Access Compliance Report

Public Rights-of-Way

Intersection ID: 15063	Main Street: DUNN_AV	Cross Street: ORANGE_ST	Location: SE
ADA ID: F15016DFF258	Ramp Type: ParaDiag	Initial Pass/Fail: Fail	Overall Compliance: No
Codes/Mitigation Info/Possible Solution		Field Measurements/Component Compliance	
Severity Score: 12.5

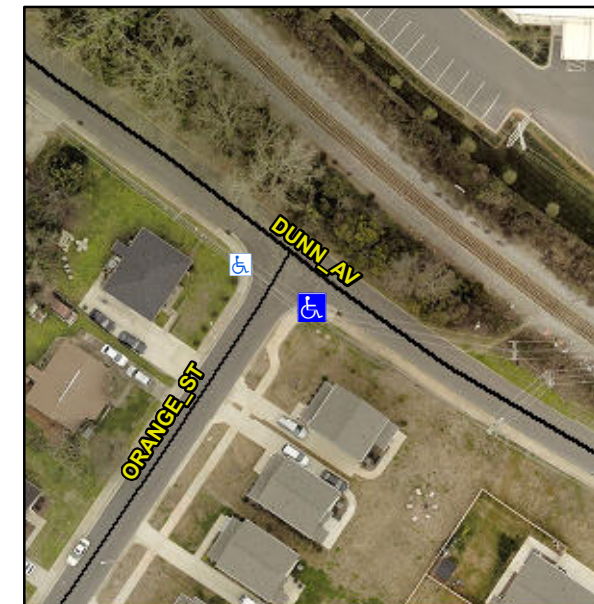
RT RP < 5%

R304.3.2

Compliance	Description	Data	Compliance	Description	Data
N/A	Ramp Length LT (in)	43.0	N/A	Ramp Length RT (in)	41.0
Yes	Ramp Width LT (in)	72.0	Yes	Ramp Width RT (in)	72.0
No	Ramp Slope LT (%)	8.7	Yes	Ramp Slope RT (%)	1.6
Yes	Ramp XSlope LT (%)	1.2	Yes	Ramp XSlope RT (%)	1.5
N/A	Landing Length (in)	N/A	N/A	DWS Provided?	N/A
N/A	Landing Width (in)	N/A	N/A	DWS Contrast?	N/A
N/A	Landing Slope (%)	N/A	N/A	DWS Length (in)	N/A
N/A	Landing X Slope (%)	N/A	N/A	DWS Full Width?	N/A
N/A	Landing Curb? (Y/N)	N/A	N/A	DWS Offset (in)	N/A
N/A	Shared Landing?	N/A			
N/A	Gutter Ponding?	N/A	N/A	Gutter Slope (%)	N/A
N/A	Gutter Lip Ht (in)	N/A	N/A	Gutter X Slope (%)	N/A
N/A	Painted X Walk1?	No	N/A	Painted X Walk2?	No
	X Walk 1 Direction	To NE		X Walk 2 Direction	To NW
N/A	X Walk 1 Width (in)	N/A	N/A	X Walk 2 Width (in)	N/A
	X Walk 1 Slope (%)	1.2		X Walk 2 Slope (%)	3.6
	X Walk 1 X Slope (%)	0.8		X Walk 2 X Slope (%)	2.8
N/A	Ramp inside XWalk1?	N/A	N/A	Ramp inside XWalk2?	N/A

Remove & Replace Curb Ramp With Two New Directional Ramps or Equivalent.
